Subject: 13<sup>th</sup> Street and Rowan Street Storage Basin  
Minor Project Modification  
IOAP Project No. L\_OR\_MF\_155\_M\_09B\_B\_B\_4  
DOJ Case No. 90-5-1-1-08254

### 2015 Project Modification Request

**Project Name:** 13th Street and Rowan Street Storage Basin

N 13th St and Rowan St Storage Basin

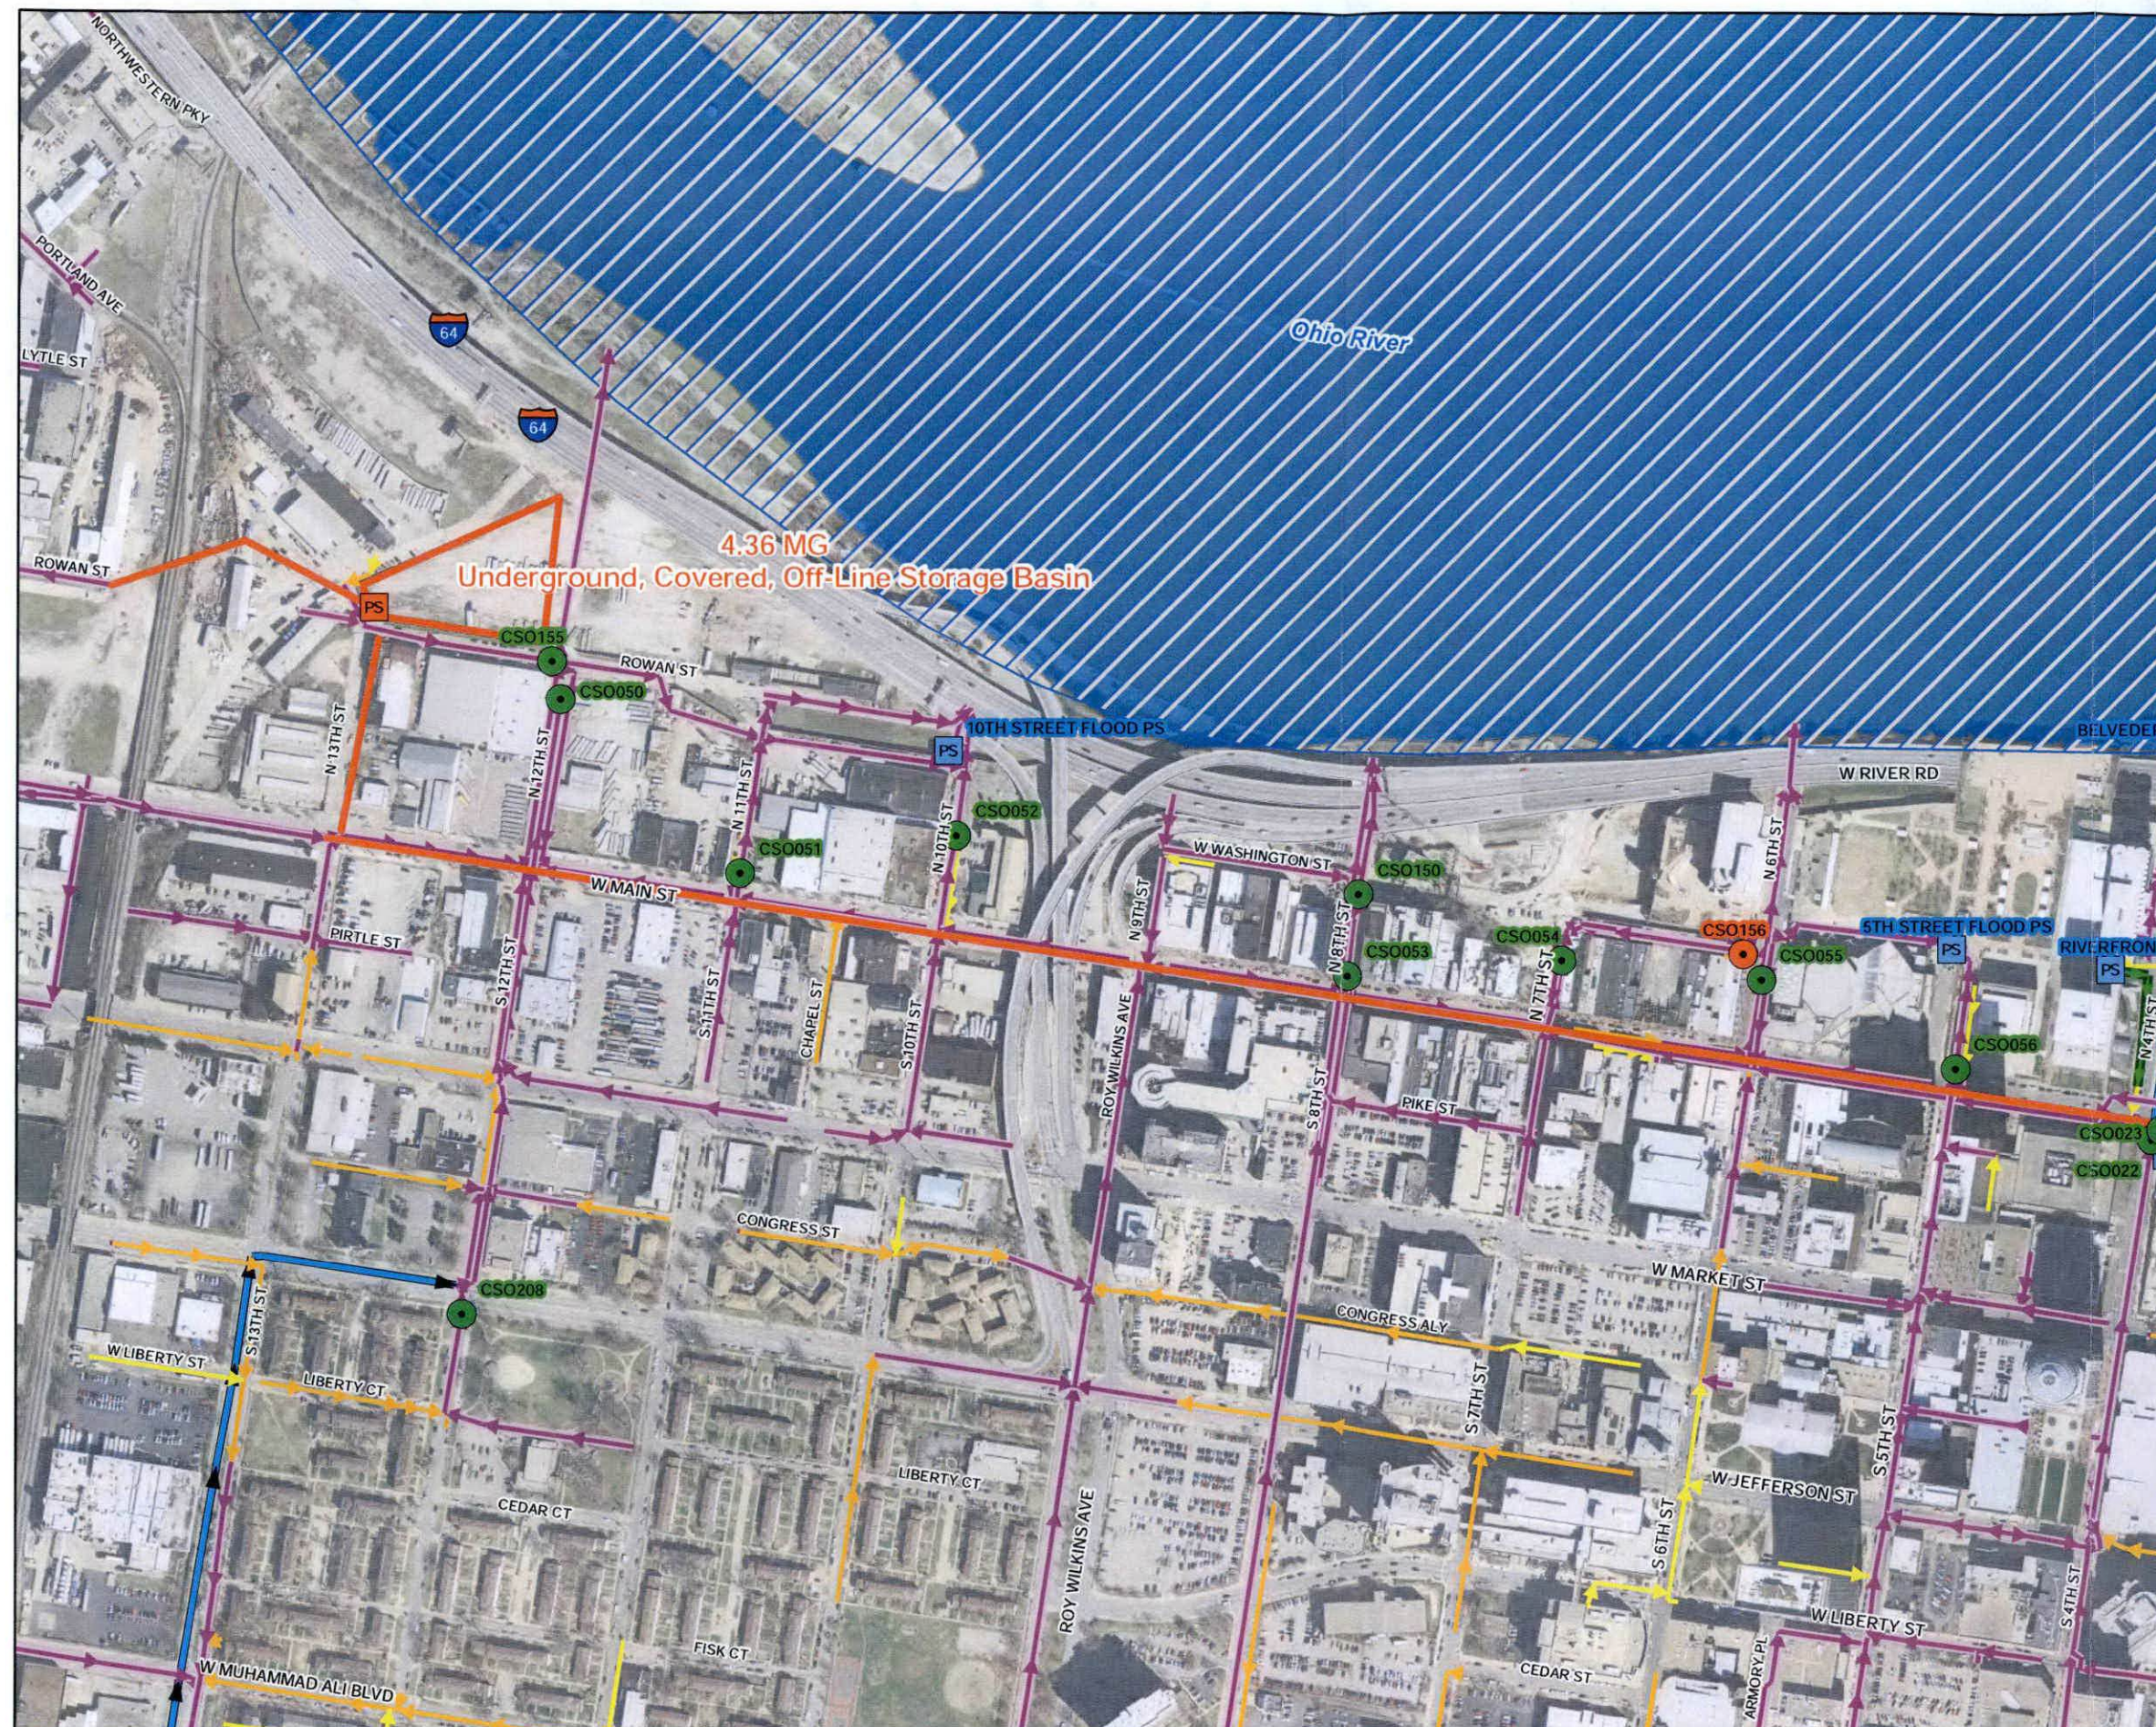
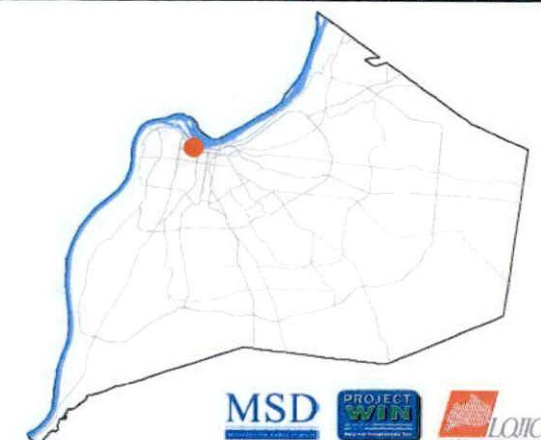
This project modification request includes increasing the 13<sup>th</sup> Street and Rowan Street Storage Basin size from 4.36 MG to 9.8 MG. The level of control is proposed to remain at 8 overflows per year in the typical year. The larger size does not reduce CSO occurrences significantly, but does provide a reduced residual AAOV. No change in project completion date is proposed.

**Project Description:** This project includes a large conveyance line from multiple CSOs and 4.36 MG underground covered concrete basin to reduce overflows to 8 overflows per typical year. This project also includes weir modifications to CSO 023 and 058. Two routes and costs for the conveyance line have been identified. The first route involves micro-tunnelling along Main Street, and the alternate route involves traditional open cut sewer installation along River Road. A right-sizing analysis may be used to potentially reduce the size of the basins or eliminate some of the conveyance lines.

**Project Description:** This project includes a large conveyance line from multiple CSOs and 9.8 MG underground covered concrete basin to reduce overflows to 8 overflows per typical year. This project also includes weir modifications to CSO 023 and 058. Two routes and costs for the conveyance line have been identified. The first route involves micro-tunnelling along Main Street, and the alternate route involves traditional open cut sewer installation along River Road. A right-sizing analysis may be used to potentially reduce the size of the basins or eliminate some of the conveyance lines.
